DOOSAN Document Transmittal Upper Trishuli-1 HEP (216MW)		Date 2022-03-10	DT No.: UT1-HEP-DHI-PC-D-0012	SHEET 1 OF 1
DOOSAN NEPAL BRANCH OFFICE	Address & Contact No. : Four Square Building, Naxal, Kathmandu, Nepal (P.O Box : 1387) + 977 1 692 3014	Project No. H20002	DOCUMENT DISPATCHED BY Courier Service ☐ Messenger ☐ Post-Air Freight ☐ Document System or E-mail ■ By hand ■	
DOCUMENT DISTRIBUTION	■ POWER CHINA (Subcontractor) ☐ Doosan's Site Office			
SUBJECT	Review Note RN-0082_Arrangement Drawing of Diversion Tunnel

REVIEW NOTE

Contractor	**Doosan Heavy Industries & Construction Co., Ltd.**		
Title of the Document	Arrangement Drawing of Diversion Tunnel, sheets 1-2		
Document No.	UT1-C-010-CVL-DG-42001	Revision	0C
Date of Documents	20.01.2022	Received Date	23.01.2022
Transmittal Form No.	UT1-HEP-DHI-D-0125		
Previous Review Date/Status	N/A	Prev. Review Note No.	N/A
Review Note No.	**RN-0082**	**Present Review Date**	**09.03.2022**
		Present Review Status	**RR**

DRAWING TITLE
ARRANGEMENT DRAWING OF DIVERSION TUNNEL(1/2)

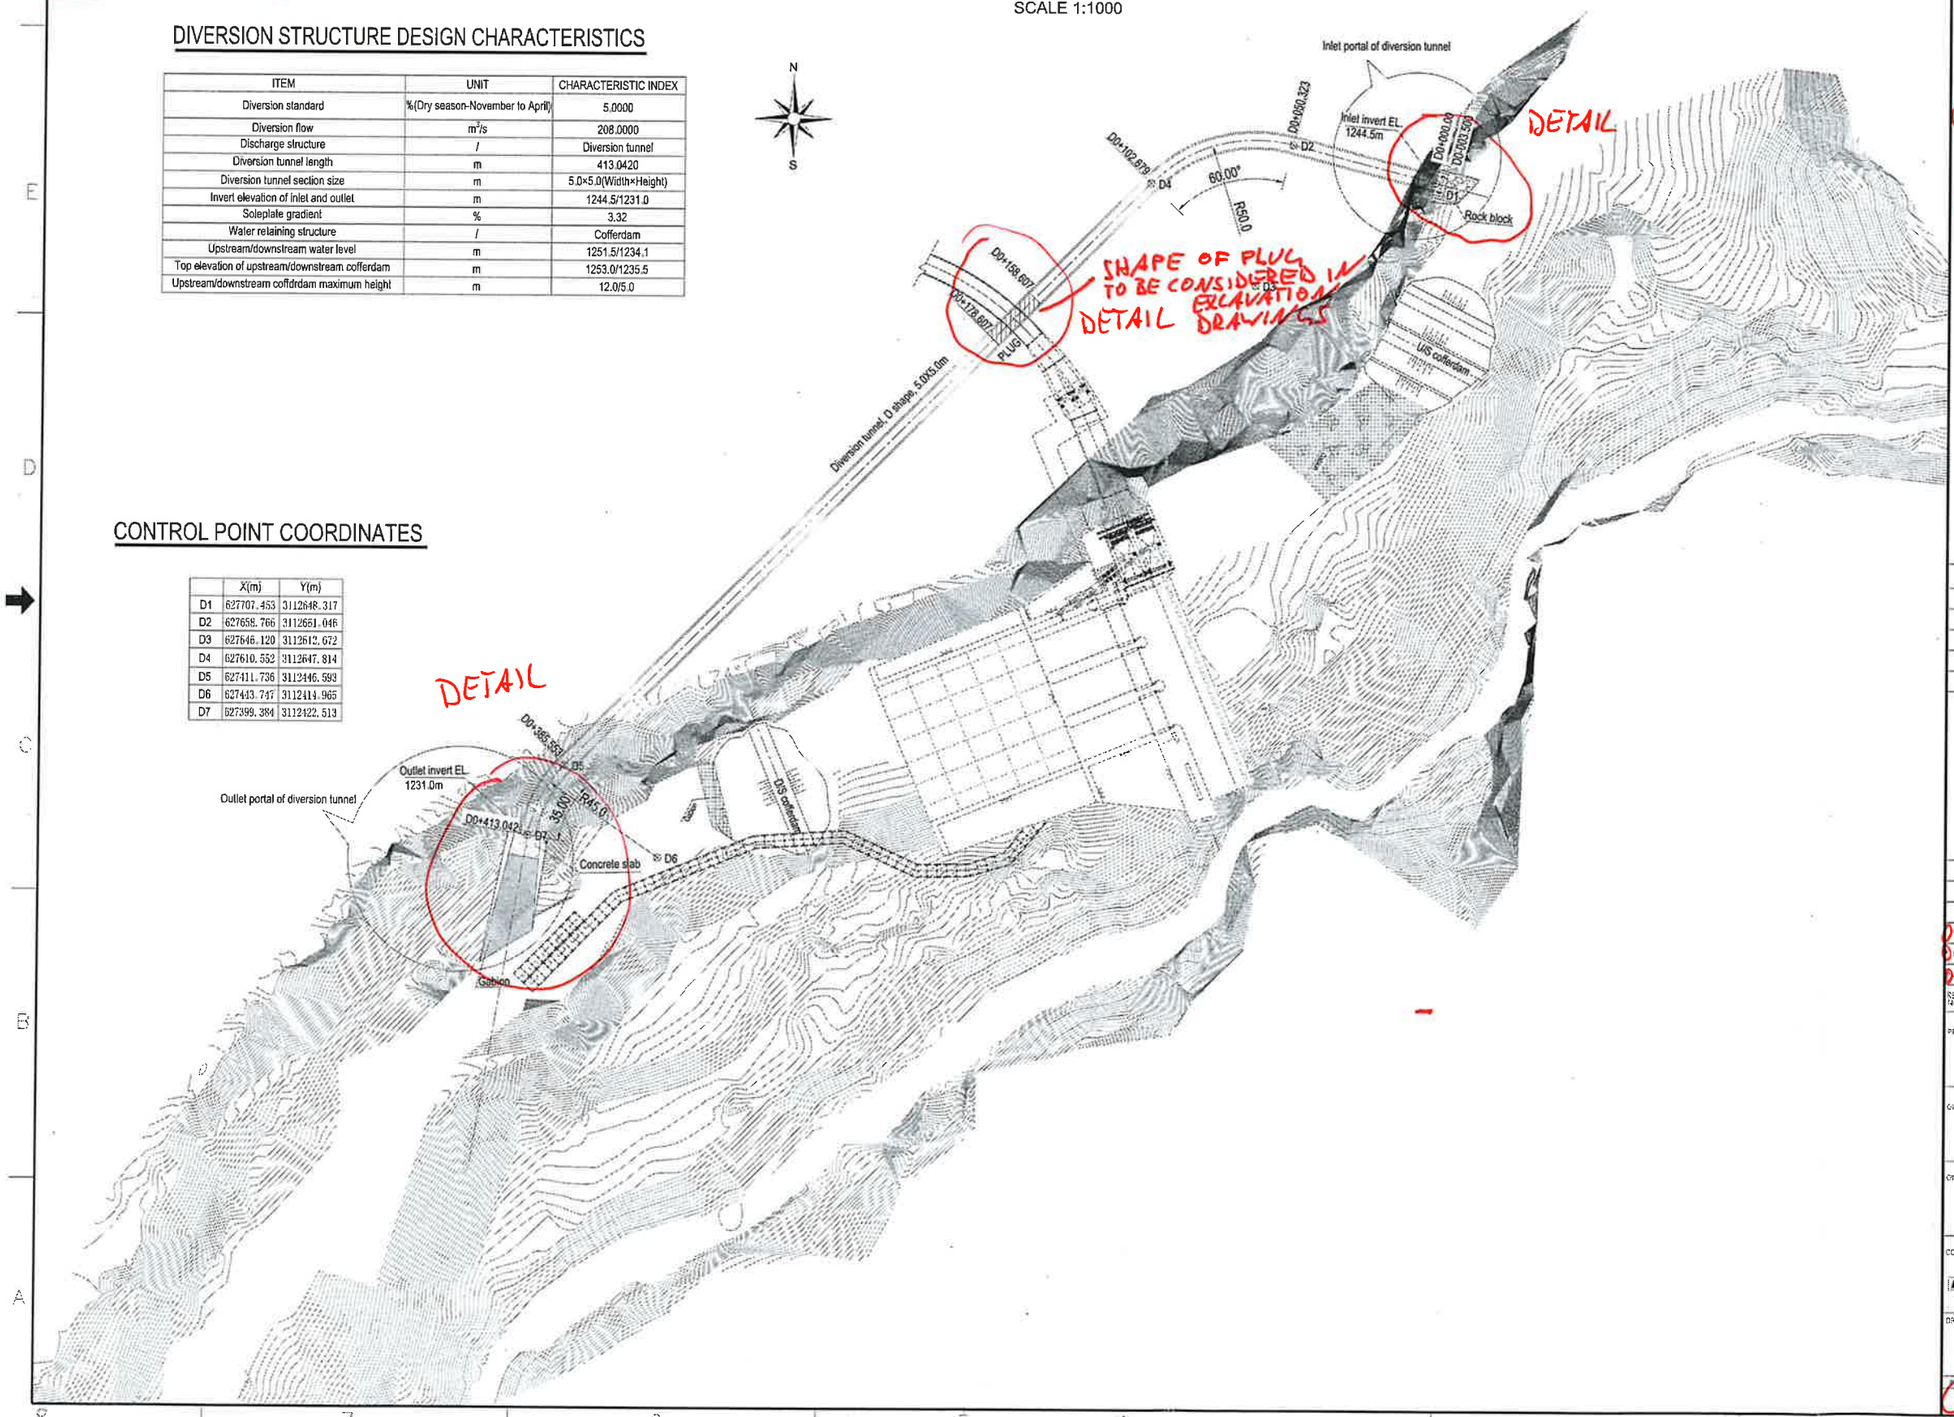
1. This set of drawings are the arrangement of diversion tunnel.
2. Elevations and chainages are in meter, other dimensions are in centimeter.
3. Structures shown on the drawing with the exception of diversion tunnel are sketches only.
4. The diversion structure design characteristics table is tentative ✓
5. The alignment etc., location of portals etc. are subject to approval 04
6. Scale:

→ SCALE IS NOT SUBJECT OF A NOTE

DRAWING TITLE
ARRANGEMENT DRAWING OF DIVERSION TUNNEL(2/2)

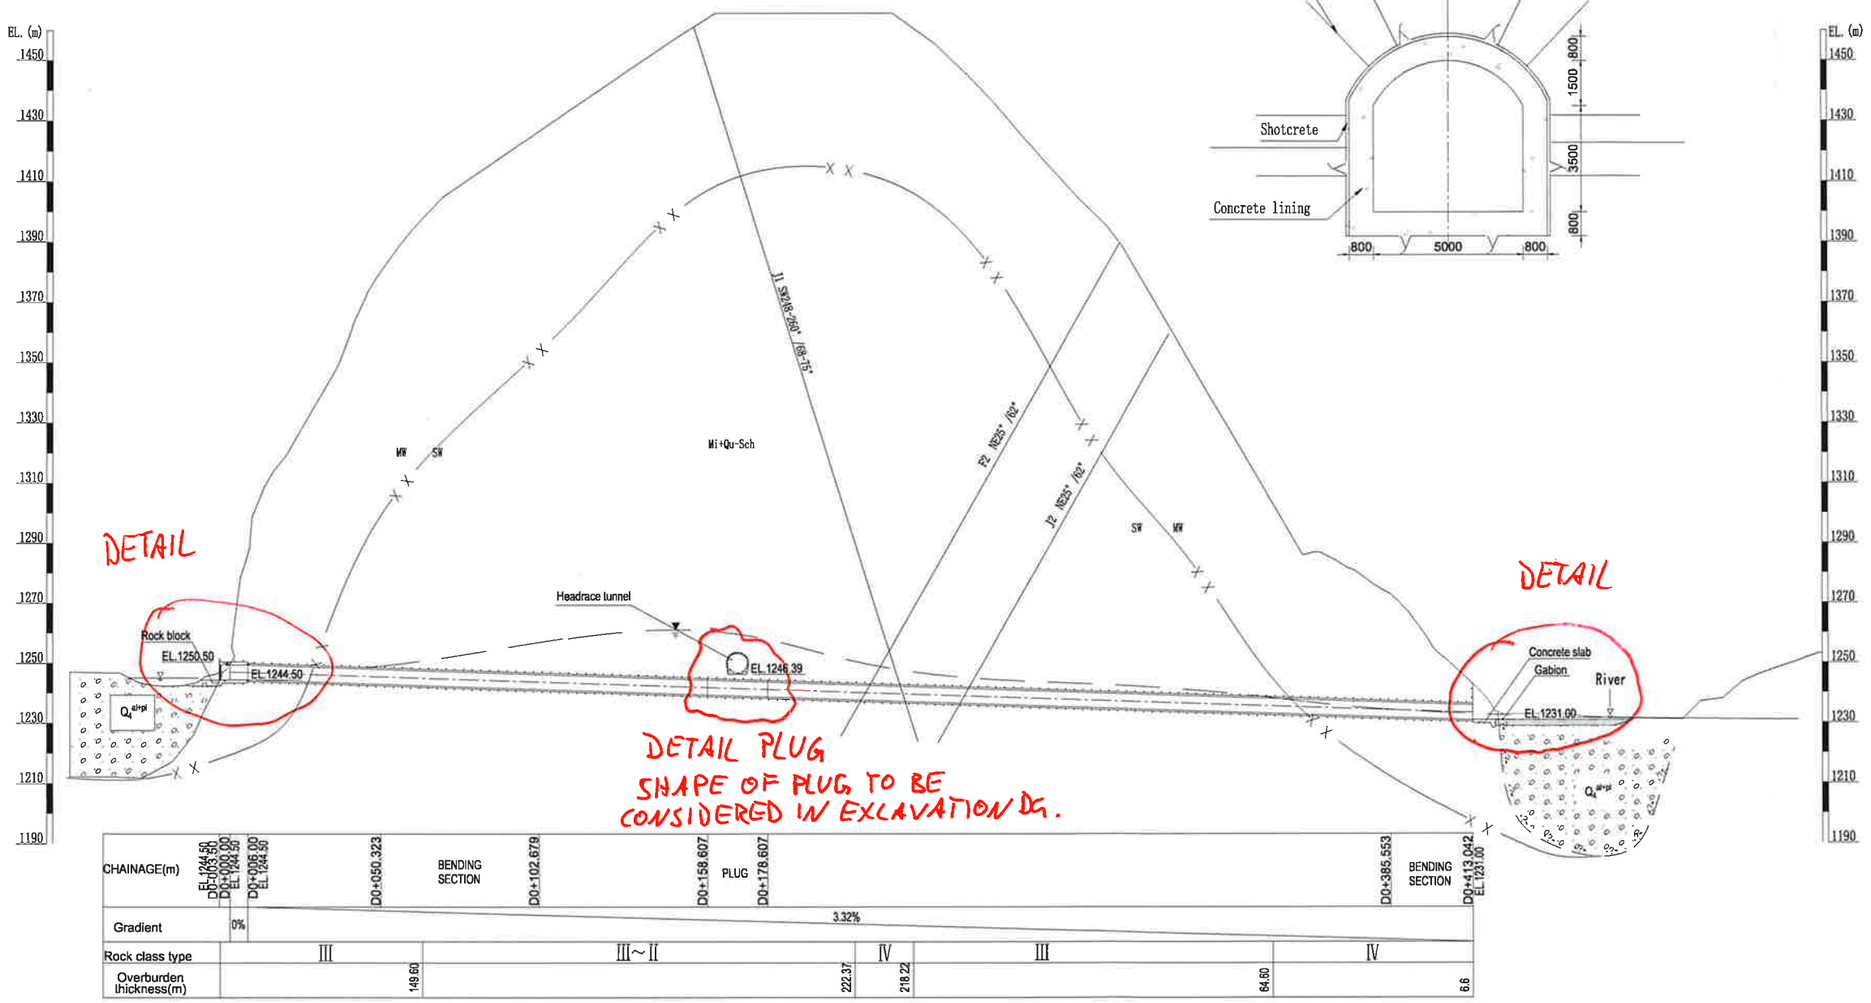
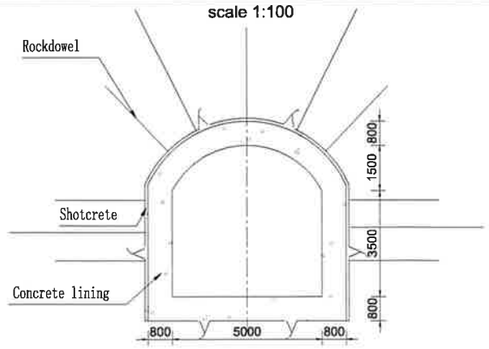
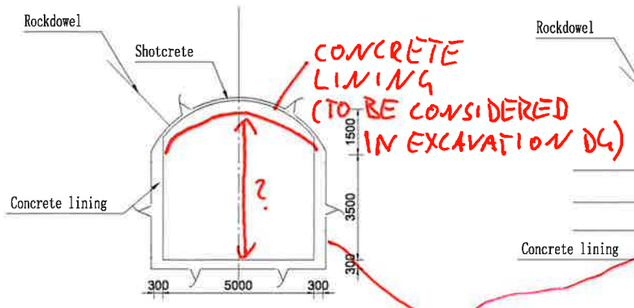
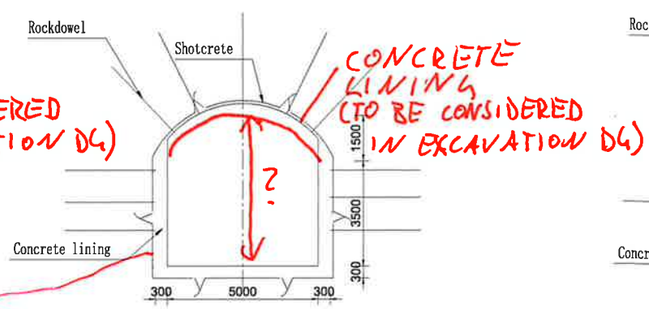
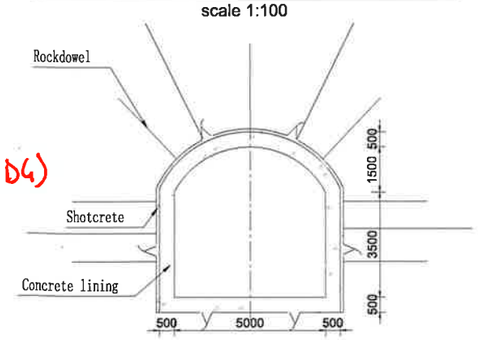
1. All dimensions are in millimeters, and coordinates, chainages & elevations are in meters.
2. Details of surrounding rock support and lining of each RMG refer to subsequent drawings.
3. The distribution of rock classes is tentative. ✓
4. ~~Tunnel support and tunnel lining are subject to approval.~~
5. Scale: OK

→ NOT SUBJECT OF A NOTE
